NUCLEAR REGULATORY COMMISSION

Title: Advisory Committee on Reactor Safeguards
 ESBWR Subcommittee on Fermi 3

Date: Wednesday, August 20, 2014

ESBWR SUBCOMMITTEE ON FERMI 3

Fermi 3 RB/FB FIRS compared to ESBWR CSDRS (5 percent damping)

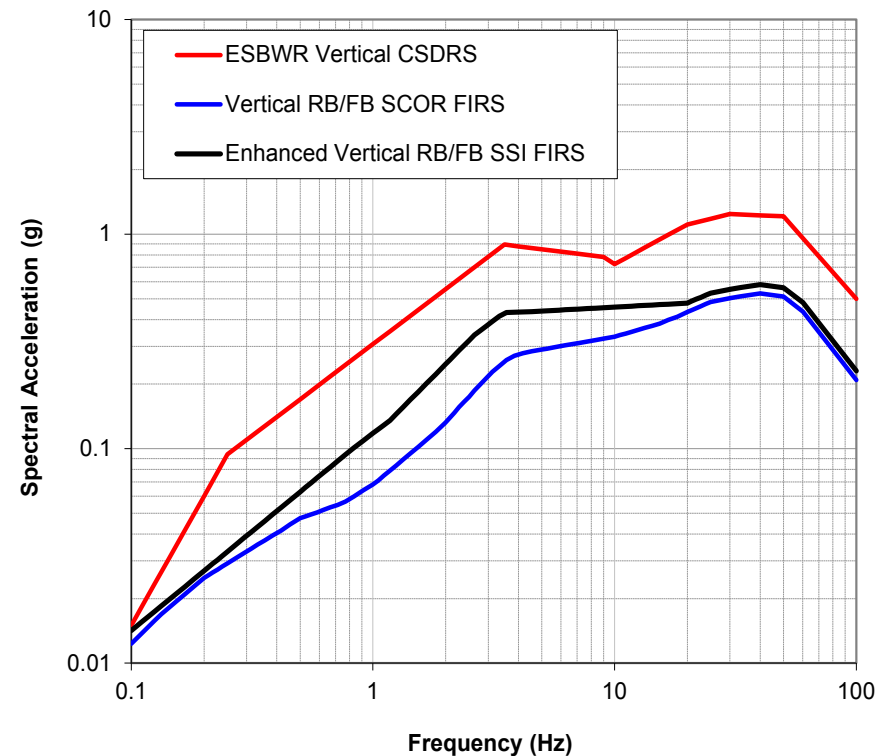
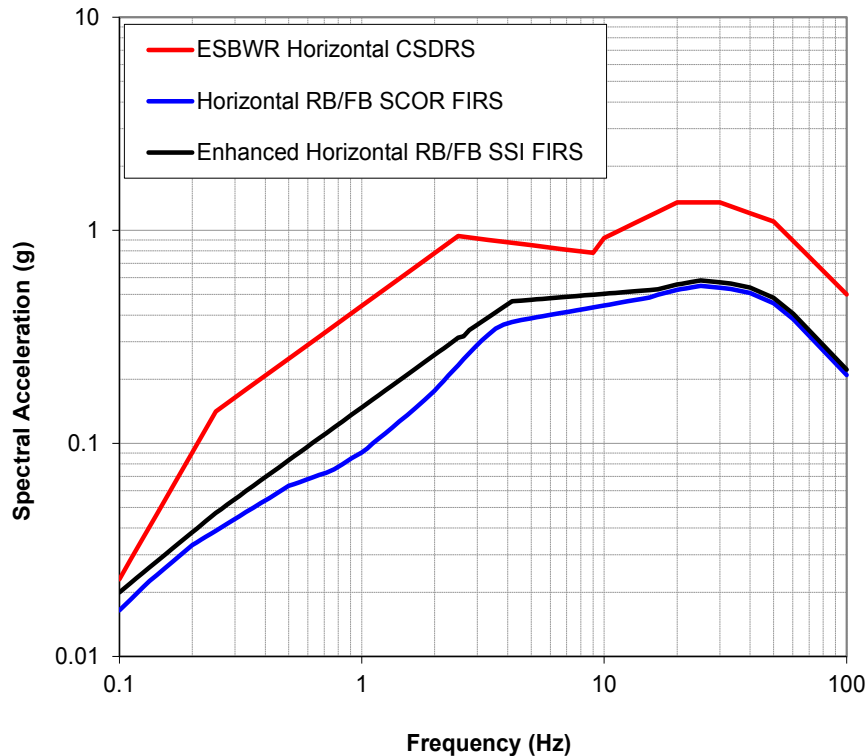
But this time you see the black line there, which is an enhanced SSI foundation input response vector that was developed using the guidance of Reg Guide 1.160 and Interim Staff Guidance 17.

And as an enhanced, and it also was enveloped by the Certified Seismic Design Response Spectra, again, with a significant amount of margin.

Vibratory Ground Motion

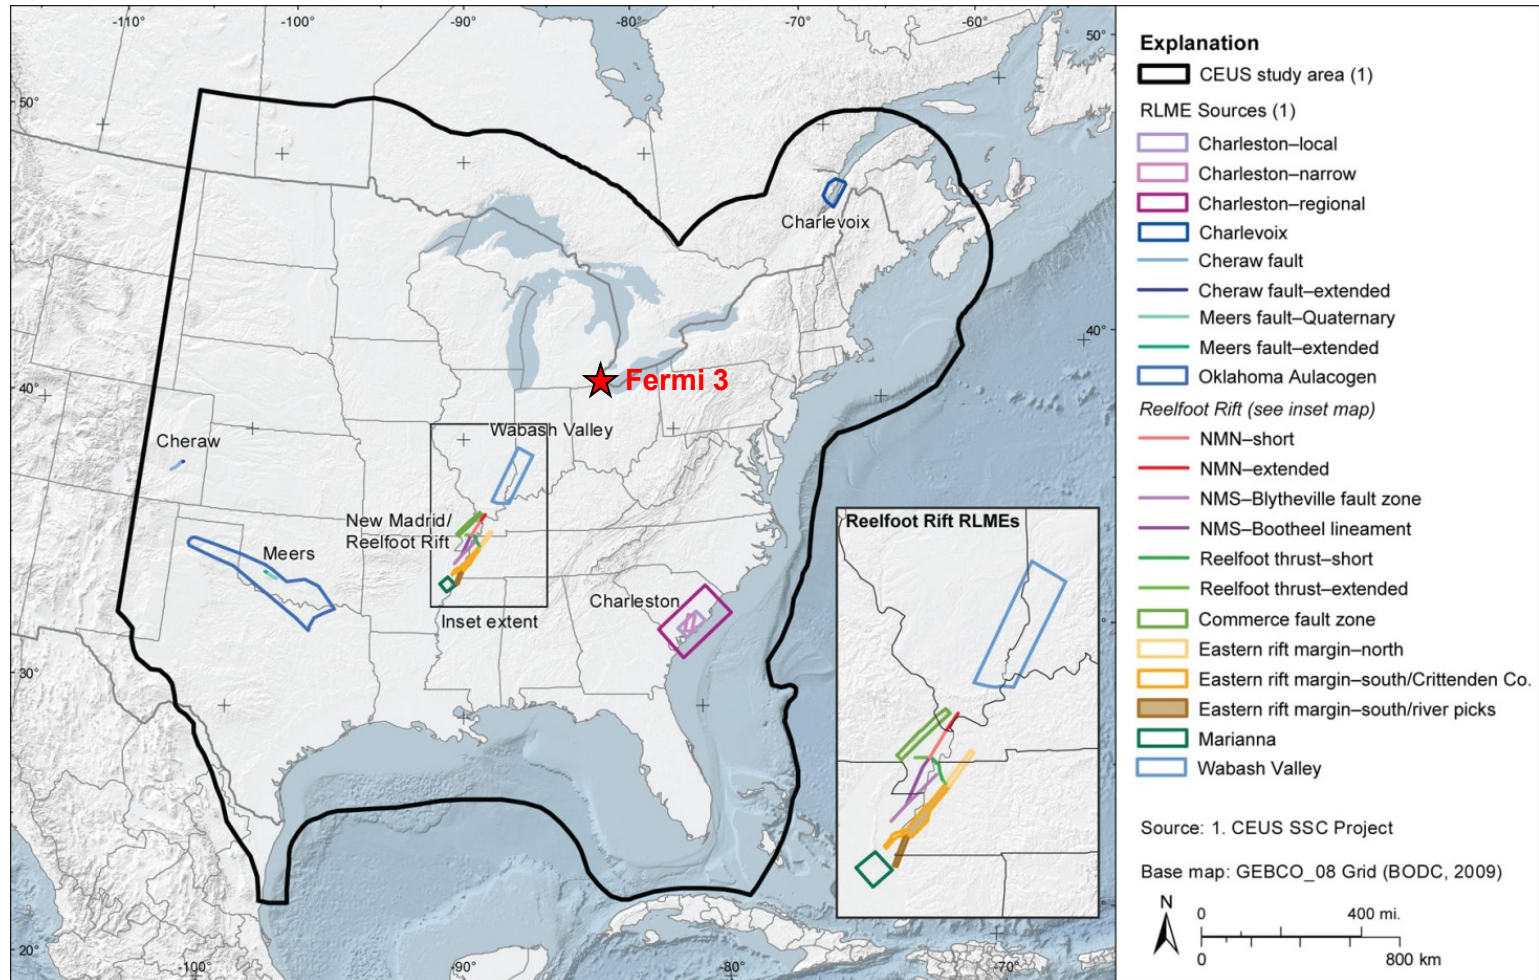
And the figure here shows the logic tree, how these sources are incorporated into the model. And as you see, there's two branches. Mmax, maximum magnitudes branch, and the

Section 2.5.2 Vibratory Ground Motion

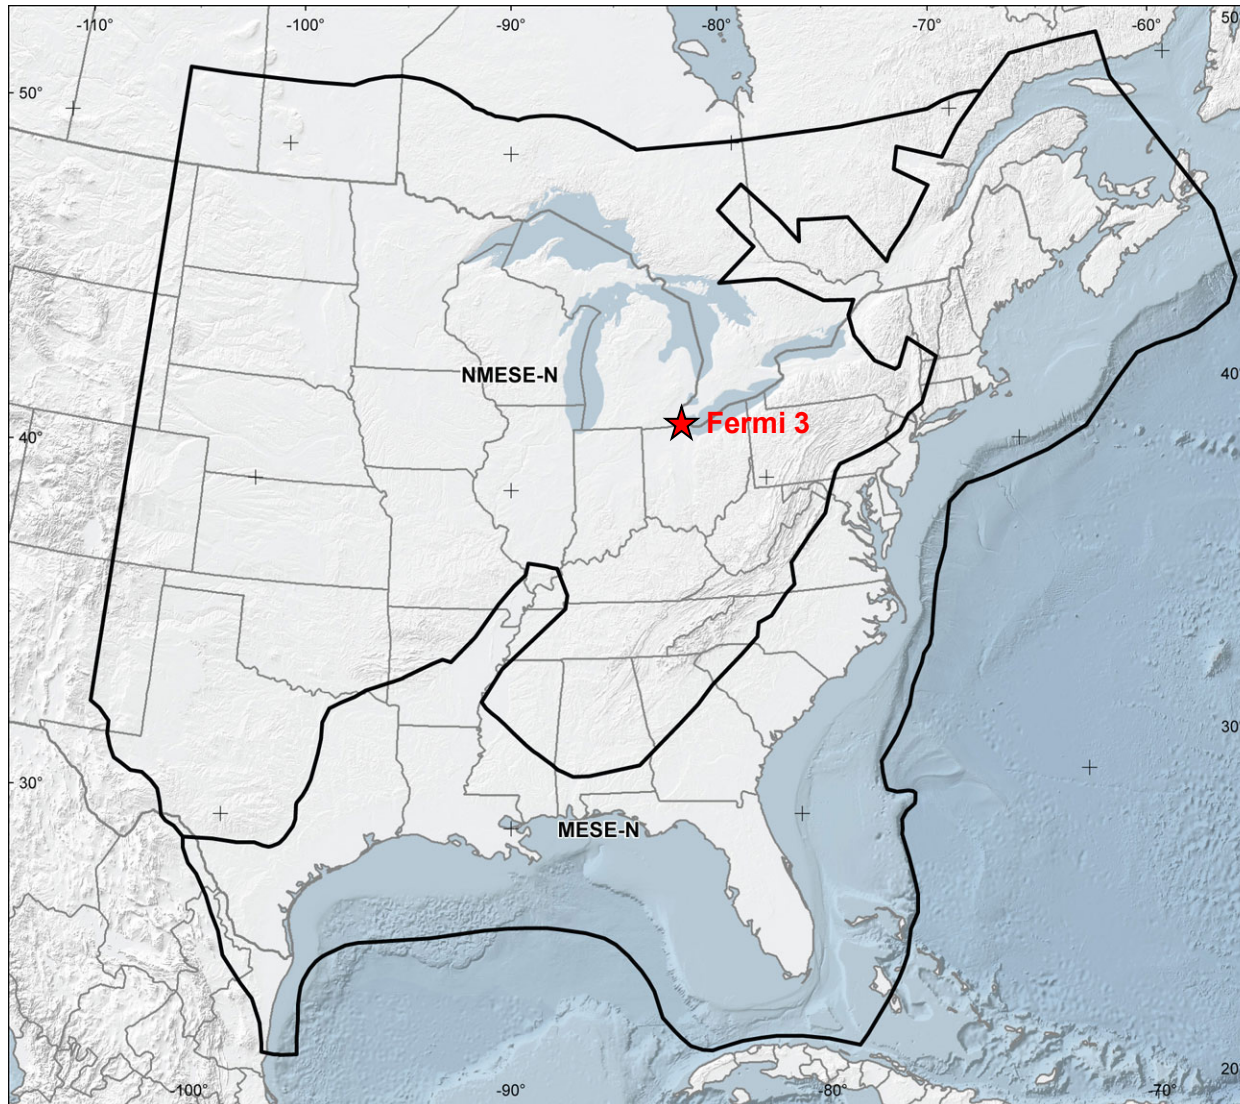
On the next slide, here this figure shows the location of the FERMI 3 site shown by the red star. And this shows the locations of the RLME sources. And you can see the New Madrid source zone is here.

Comparison of Applicant's EPRI-SOG and CEUS-SSC Results

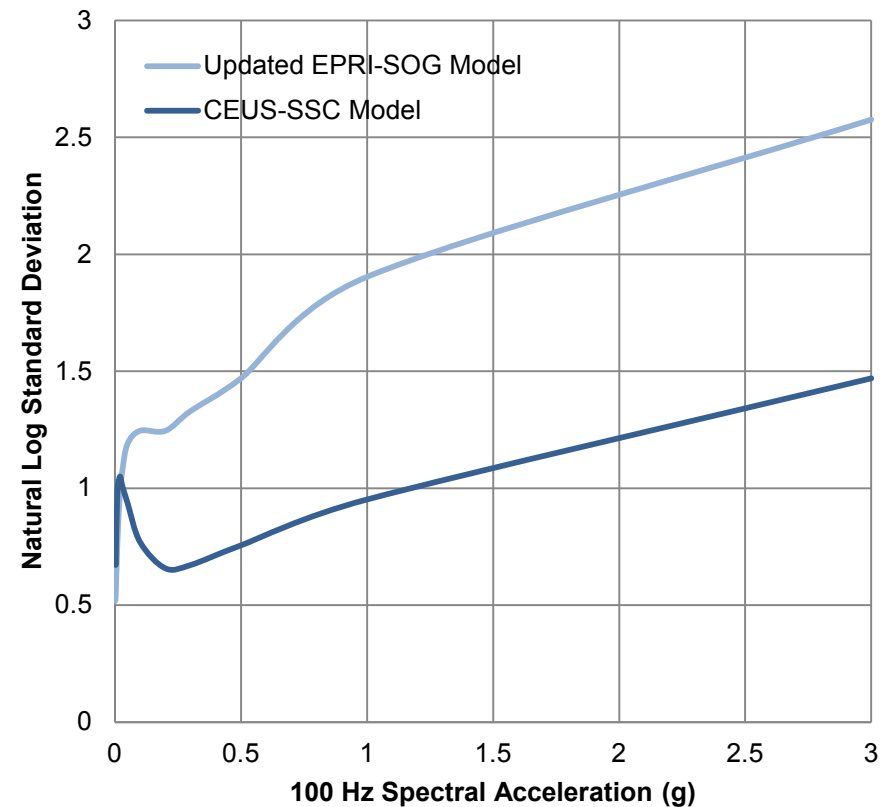
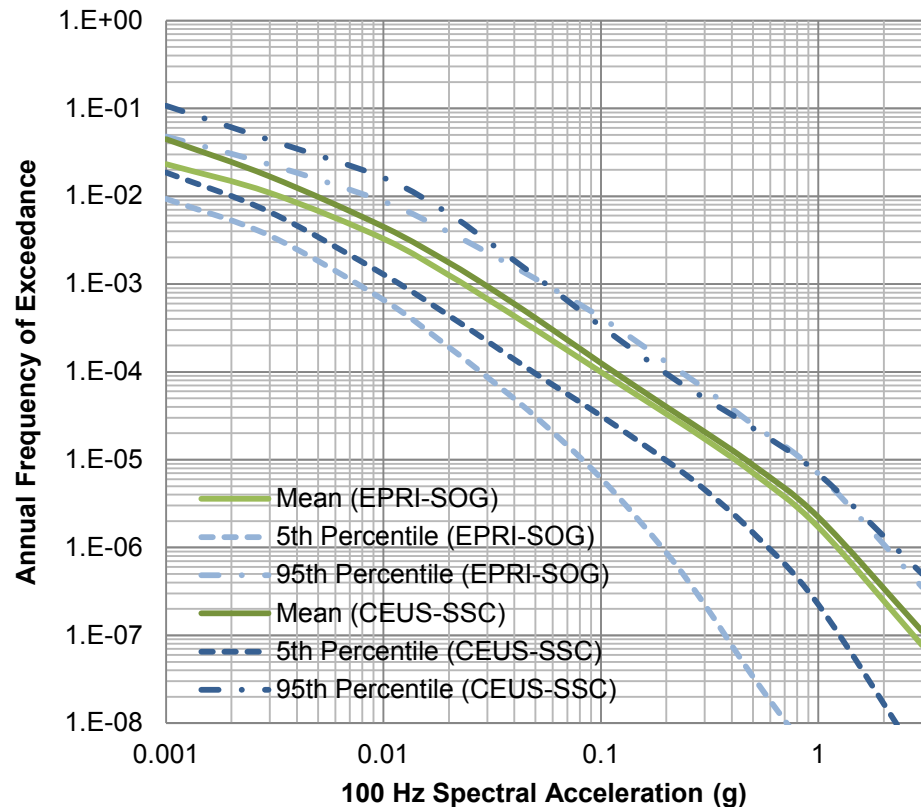
MS. TABATABAI: So, in response to the Recommendation 2.1 RAI, the applicant provided hazard curves including the mean and percentile curves for the CEUS SSC models, as well as the updated EPRI-SOG model so we could compare those.

On the next few slides, I compare the applicant's EPRI and CEUS SSC rock hazard curves. And I also show there's some corresponding uncertainty.

So, the hazard curve figure I plotted, here I plotted the mean hazard curve per the EPRI-SOG, which is the lighter green curve. And the darker green curve is the mean for the CEUS SSC model.

MR. AKE: This is Jon Ake from the Office of Research. And if I could make a comment on that, Dr. Stetkar, I think it's B I would say that if you look at the uncertainty that's portrayed in the plot on the left that Sarah is showing us there, the difference between the fifth and 95th percentile, you know, the metric of merit we're looking at really is the B are the values on the Y axis which would be the annual frequency of exceedance.

The difference between the curves that Sarah is showing between the CEUS SSC, the more recently developed model, and the older EPRI-SOG model which was developed in the '80s, is really the difference in the fifth percentiles as you'll notice from looking at that figure.

Figure developed from Applicant's results provided in SER Figure 2.5.2-12 and the Staff's results shown in SER Figure 2.5.2-13 (corresponding to a $Q_s=40$)

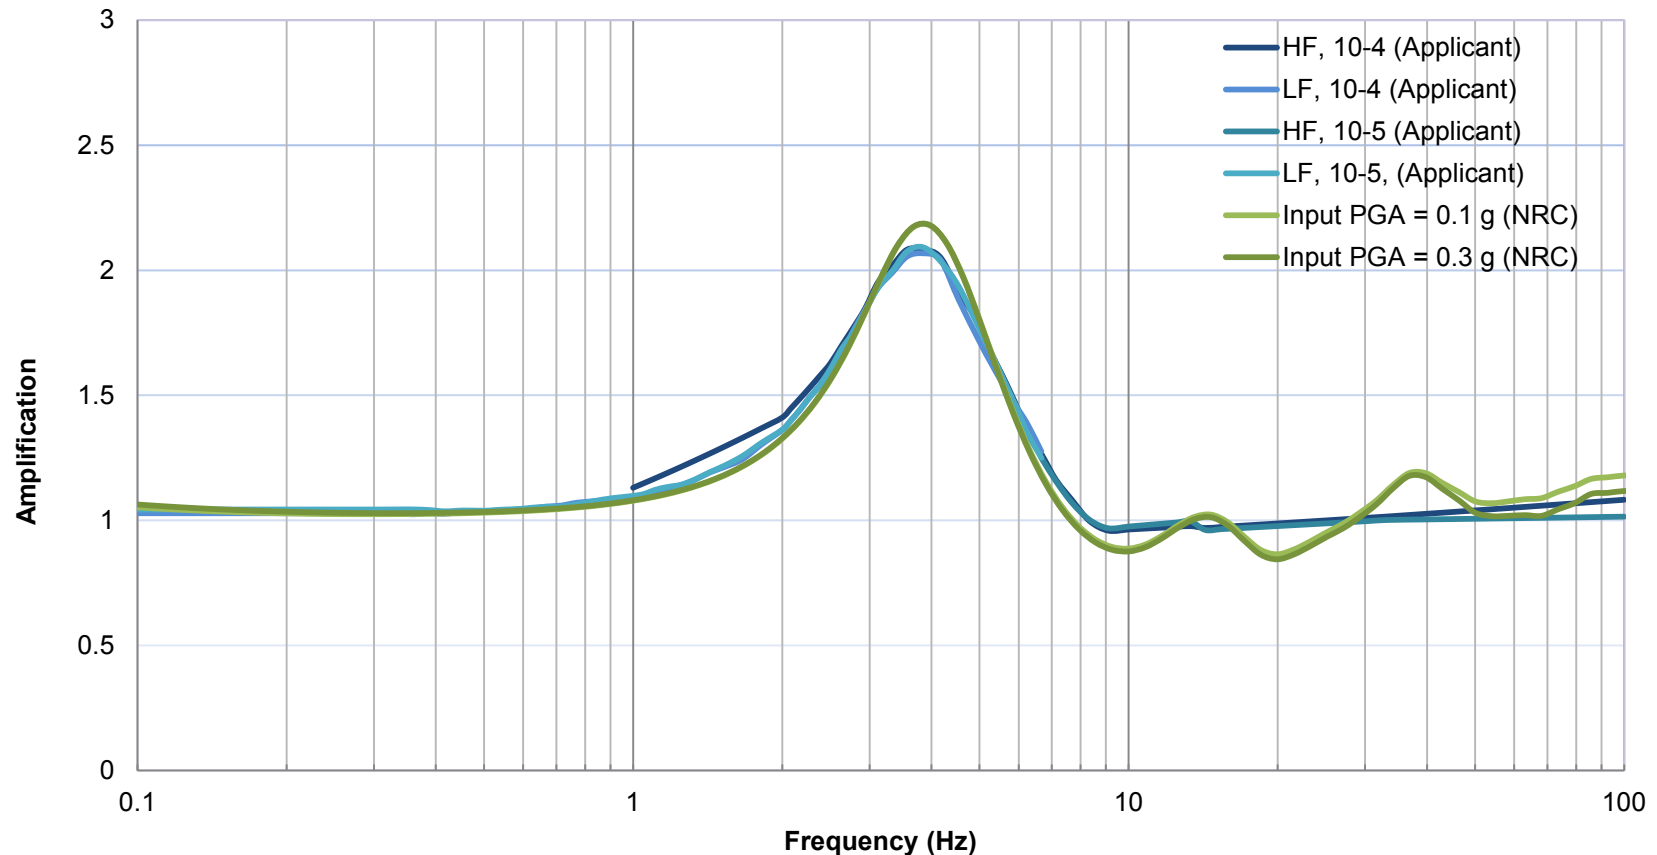
The next slide, we also did a site response confirmatory analysis. And there's a very good comparison between applicant's results and our results as well.

Fermi 3 Site Plan View

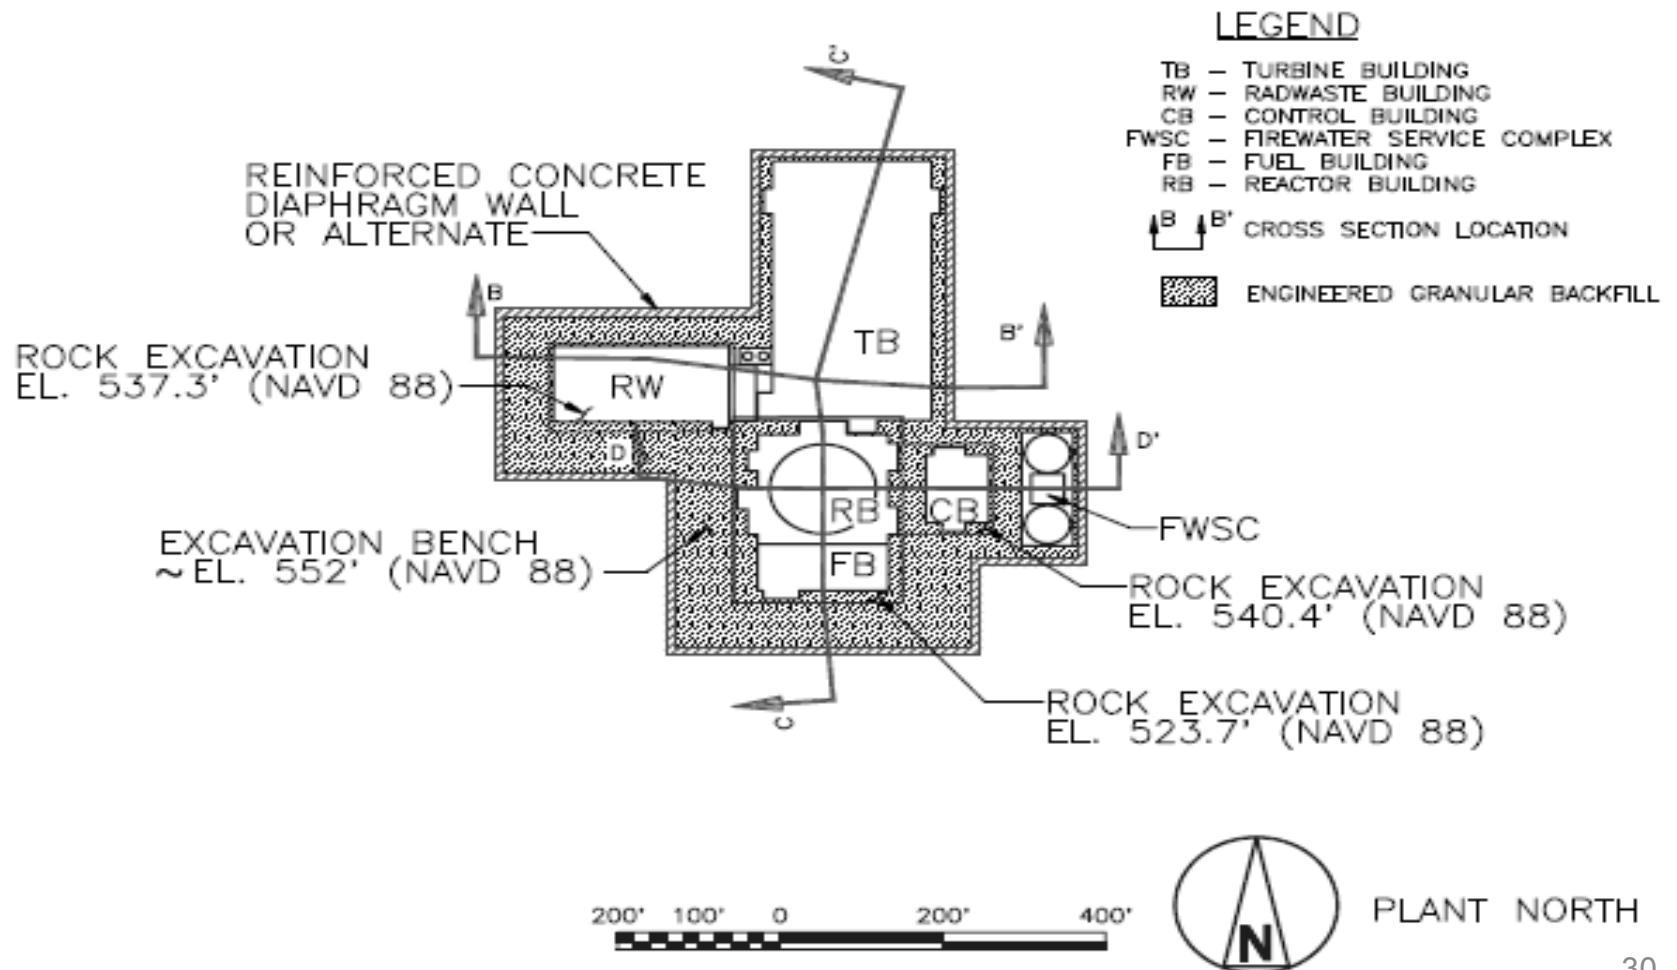
This slide figure shows the plan view for the excavation for ESBWR technical structures including seismic Category 1, reactor building, fuel building, control building, fire water service complex. Seismic Category 2, turbine building and non-seismic radwaste building.

Fermi 3 Cross Section D-D'

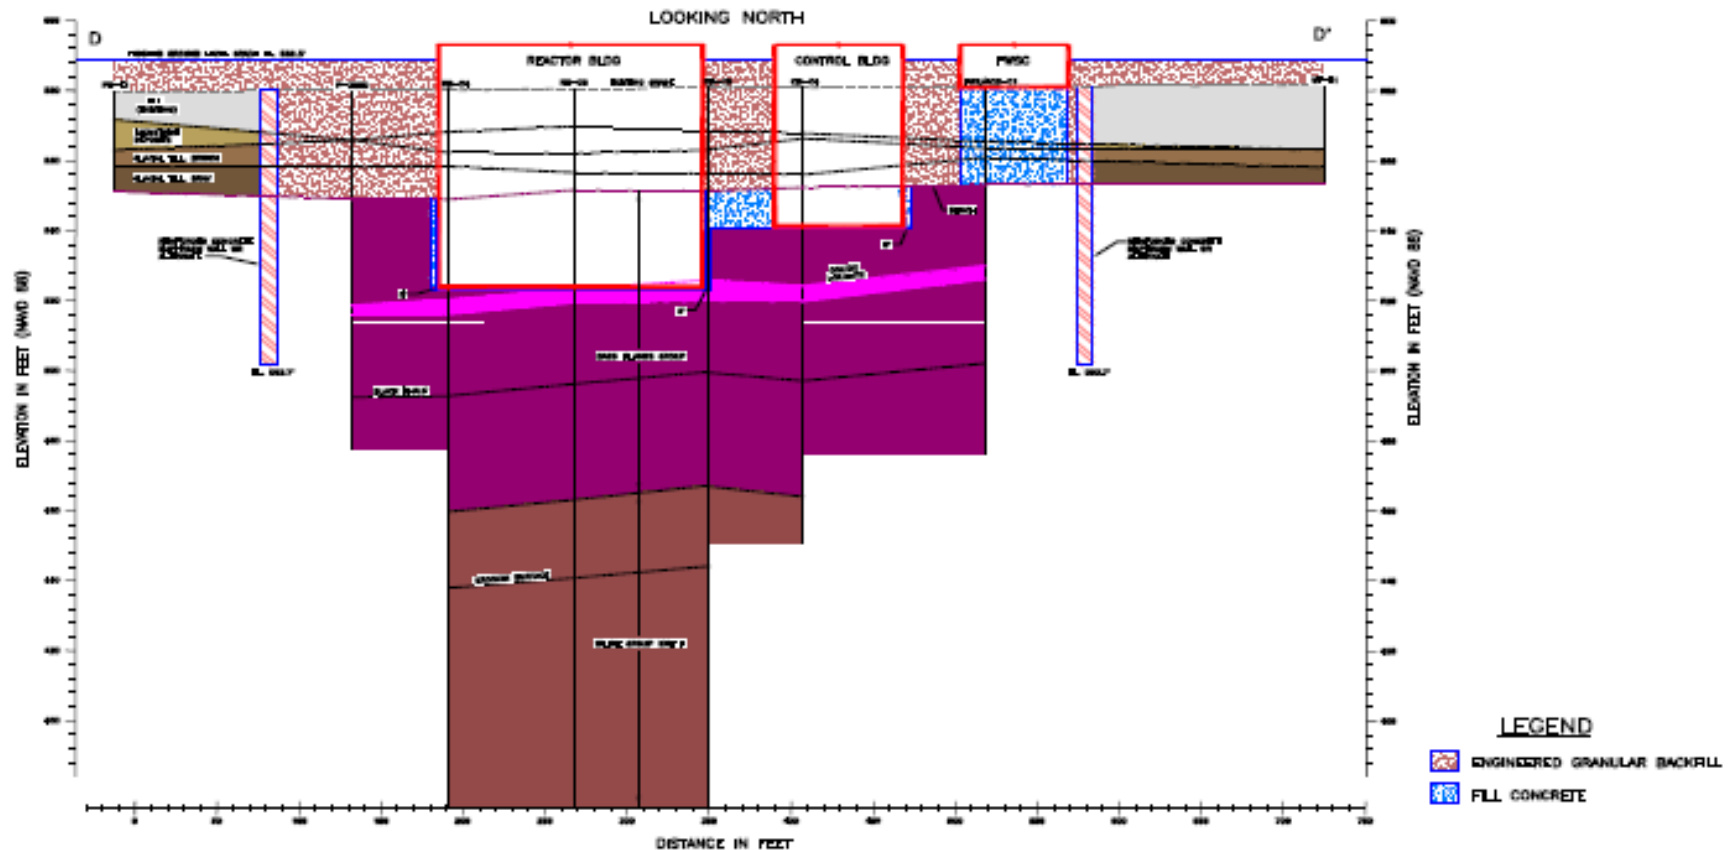
Next slide. Now, this slide is previous showed by the applicant. So, this figure shows one of the cross-section which demonstrates the relationship among structure. So, rock, excavation and backfill.

This is a vertical B this is reinforcing diaphragm wall which extend to the B into the bedrock where it acts as a parameter of the soil excavation and it will provide a vertical excavation support and seepage control.
